January 11, 2021

Mr. Mike Lovick
Cherry Creek School District
4850 S. Yosemite Street
Greenwood Village, CO 80111

Comments: 02/10/2021

Cherry Creek Elementary School No. 45 (LSC #200810)

Figure 7

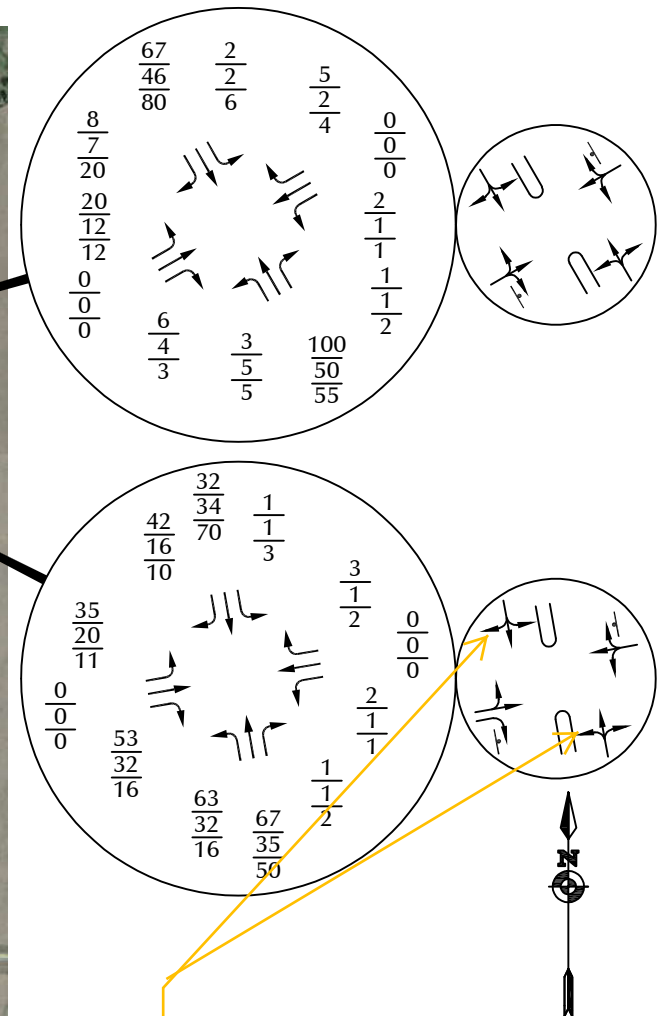
Show auxiliary lane recommendations and lengths. Also show the double stop condition for all laneage figures.

Figure has been updated.
